Letter Of Justification

THE VILLAGE AT GRAY'S CROSSING HOTEL / CONFERENCE CENTER

PROPOSED AMENDMENT OF CONDITION 14C – PARKING FOR 3RD FLOOR LOUNGE/BAR

Subject: RE: Village at Gray's Crossing Hotel Project Amendment #2 - Complete Letter

OPTION #2 - Construction of Car Wash Parking (13 Spaces)

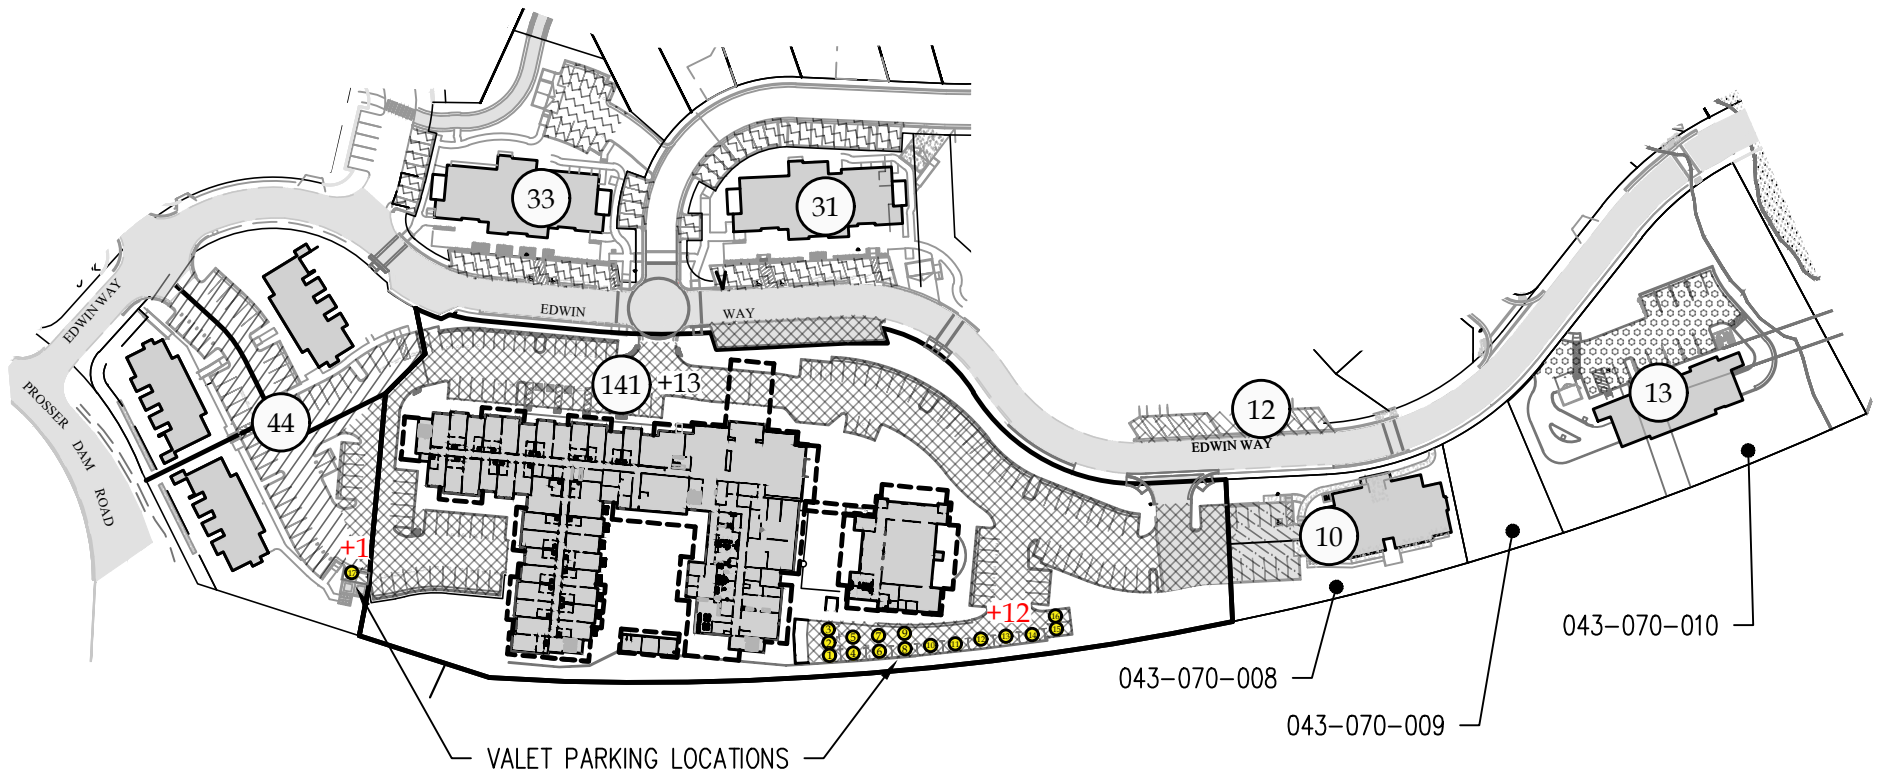
- 2 of the valet parking spaces (numbers 12 and 13 on the south side) of are existing parking spaces that are already approved. These do not add to the overall parking count. I think the overall parking capacity needs to increase by a difference of 13. I think additional stacking of cars would be required in the aisle.

- The parking exhibit shows "+9". Is this correct? Is this intended to show that there are 11 additional parking spaces? The narrative indicates that there are 14 spaces with 10 new spaces and 4 existing spaces. I am not sure if this all matches. Can you clarify or update the documents?

- **We are utilizing four (4) of the existing spaces in that area and were +10 spaces. Per your comment we have added three (3) additional valet spaces in the isle to be +13 as requested (see attached revised exhibit).**

- **Described above. We are now Plus + 13 spaces. (see revised exhibit)**
- The solid waste team stated that parking of the area will have to remain clear up until 5 PM Monday-Friday for trash/recycling pick-up (see attached). I will be adding this as a condition and the parking management plan will also be required to acknowledge this. I imagine that there will be an inherent desire to ensure trash is picked-up and the hotel will be motivated to manage this. **Agreed. We don't want to impede trash pick-up, as such the parking plan starts at 5 and will follow pick-up for trash that may occur on a given day.**
